Project	<b>IEEE 802.16 Broadband Wireless Access Working Group</b> < <a href="http://ieee802.org/16">http://ieee802.org/16</a> >	
Title	<b>Proposal for a new PDU concatenation scheme to facilitate MAC PDU separation under error conditions</b>	
Date Submitted	<b>2004-03-13</b>	
Source(s)	<p>Sunny Chang, Bonggee Song, Taein Hyon, Yunsang Park</p> <p>Samsung Electronics 416, Maetan-3dong, Paldal-gu Suwon-si, Gyeonggi-do Korea</p>	<p>Voice: [82-31-279-5286] Fax: [82-31-279-5515] <a href="mailto:sunny94@samsung.com">sunny94@samsung.com</a>, <a href="mailto:bonggee.song@samsung.com">bonggee.song@samsung.com</a>, <a href="mailto:taein.hyon@samsung.com">taein.hyon@samsung.com</a>, <a href="mailto:yunsang.park@samsung.com">yunsang.park@samsung.com</a></p>
Re:	New PDU concatenation scheme for IEEE 802.16d	
Abstract	This contribution proposes a new PDU concatenation scheme for enhanced PDU separation in IEEE 802.16d/D3-2004.

# Proposal for a new PDU concatenation scheme to facilitate MAC PDU separation under error conditions

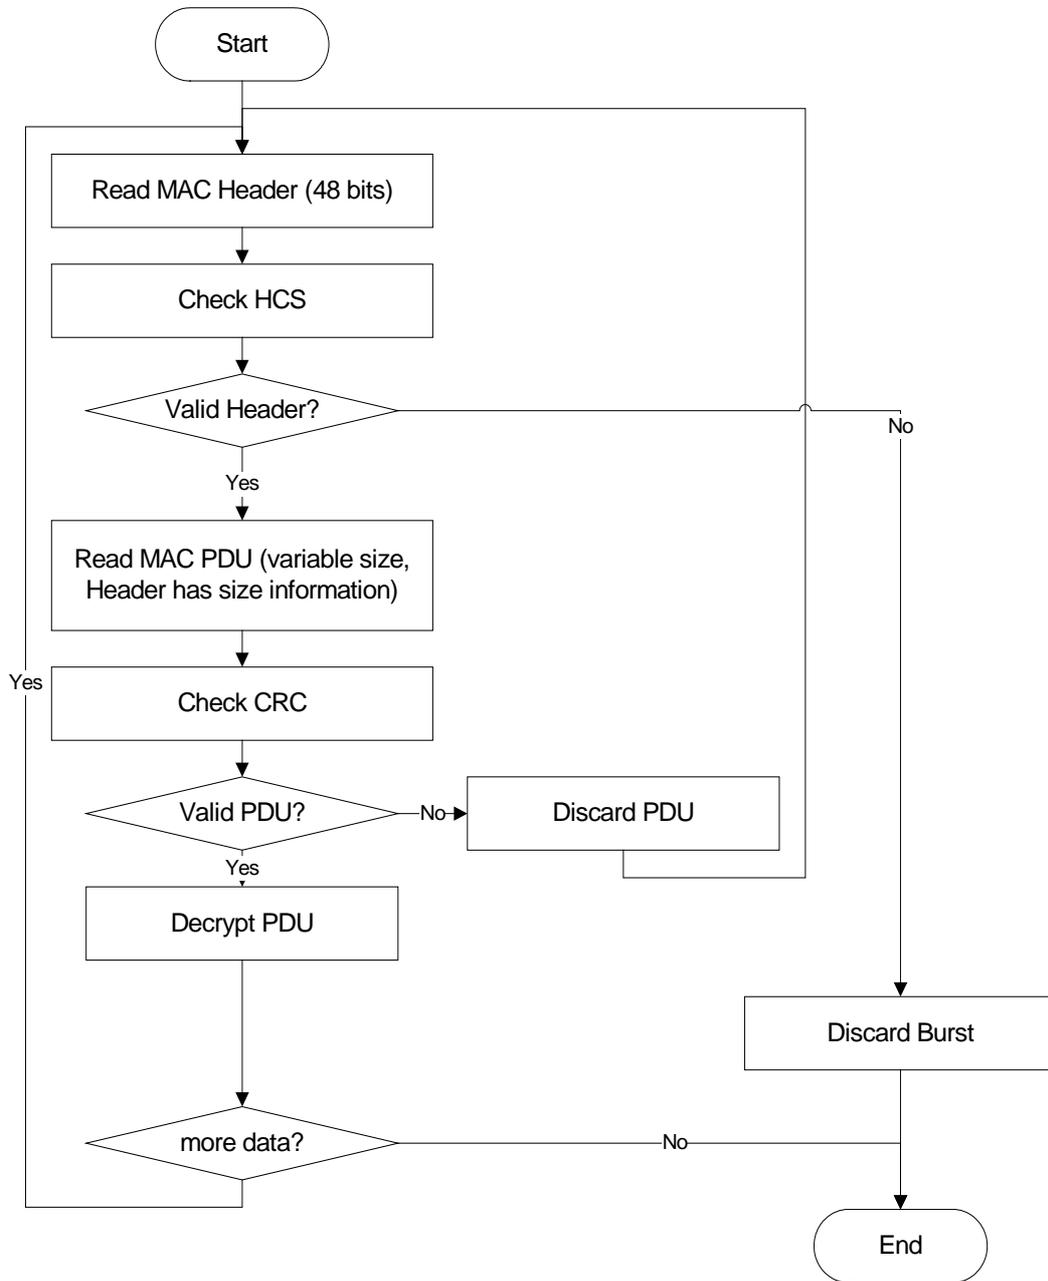
- 1) Read the first MAC header of the burst – the first 48 bits of the first MAC PDU
- 2) Check the validity of the MAC header using HCS. If an error occurs, the whole burst is discarded.
- 3) If the MAC header is valid, extract the size information of the PDU from the length field.
- 4) Read the first MAC PDU according to the size information and check the validity of the data. If the header is a bandwidth request header, this step is not necessary and will be skipped.
- 5) Read the next 48 bits. The receiver regards this as the next MAC PDU header.
- 6) Repeat Step 2) ~ Step 5) until all the MAC PDUs are read.

The following flow chart describes the sequence.

In this scheme, receivers must obtain the size information for the previous PDUs to correctly determine the starting point of the following MAC PDU. Therefore, if there is an HCS error in any of the previous MAC headers, the following PDUs cannot be separated and needs to be discarded.

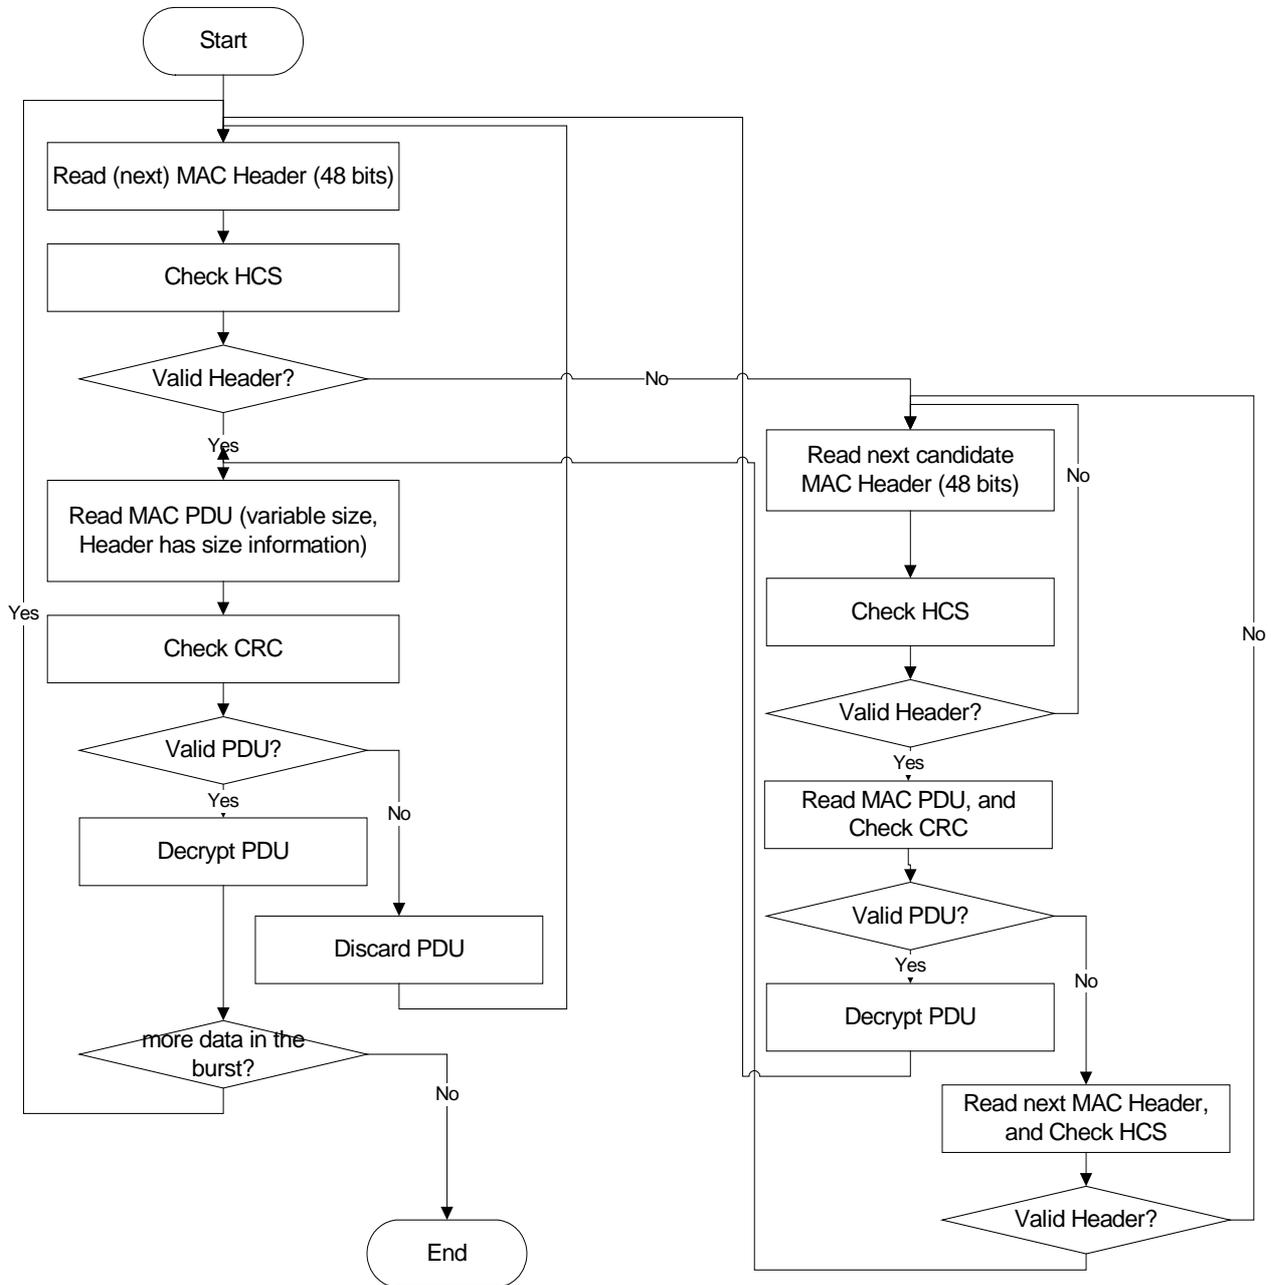
The receiver separates the concatenated PDUs in case of an error in any of the MAC headers in the following sequence;

- 1) If the MAC Header isn't valid, read the first 48bit data which has a possibility to be a MAC header and check its validity using HCS.
- 2) If the 48 bit data is deemed valid by passing the HCS check, then the size information of the PDU is extracted from the length field. Otherwise, go back to step 1)
- 3) Read the current MAC PDU according to the size information and check the validity of the data using CRC. If the header is a bandwidth request header, this step is not necessary and will be skipped.
- 4) Read the next 48 bit data and check the validity of the MAC header using HCS.
- 5) If either the current PDU in step 3) or the next MAC header in step 4) is valid, the MAC Header, which was found in step 2), is considered correct.
- 6) If neither of them is considered valid, repeat Step 1) ~ Step 5) until the next MAC header is found.

The following flow chart describes the sequence.

The following figure describes the new concatenation scheme.

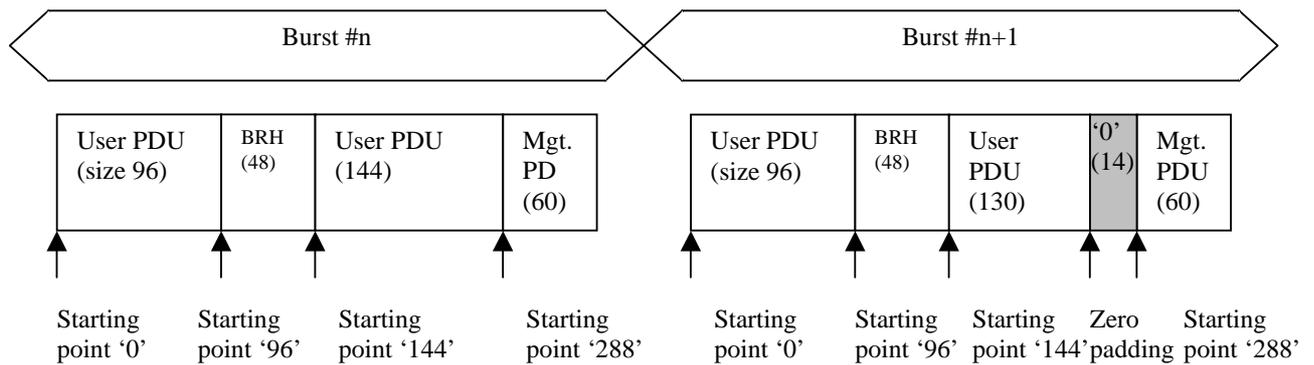
In the current concatenation scheme, because the size of the MAC PDU is arbitrary, the consecutive MAC PDUs can be located at any bit position in the burst. So when an error occurs in a MAC header, in order to find the next MAC header, the validity is checked by using HCS at all positions. This increases processing complexity.

To resolve the issue with minimal increase in processing complexity, we propose to restrict the MAC PDUs' starting point to a multiple of 48bits in a burst. For the case where the connection does not allow fragmentation or packing, the size of the PDUs' can't necessarily be a multiple of 48 bits. In this case, zeroes need to be padded between the end of the previous PDU and the start of the next PDU.

Figure 26—MAC PDU concatenation showing example CIDs

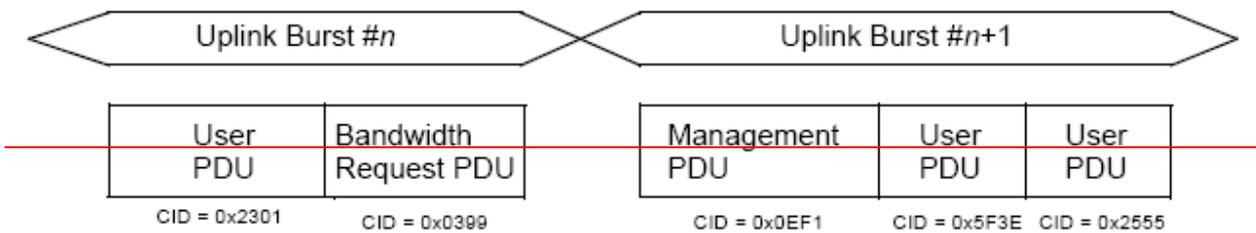
Multiple MAC PDUs may be concatenated into a single transmission in either the uplink or downlink directions. When multiple MAC PDUs are concatenated into a single transmission, the starting position of each of the MAC PDUs have to be located at a multiple of 48bits position from the start of the burst. If necessary, zeros will be padded between the end of the previous PDU and the start of the next PDU. Figure 26 illustrates this concept for an uplink burst transmission. Since each MAC PDU
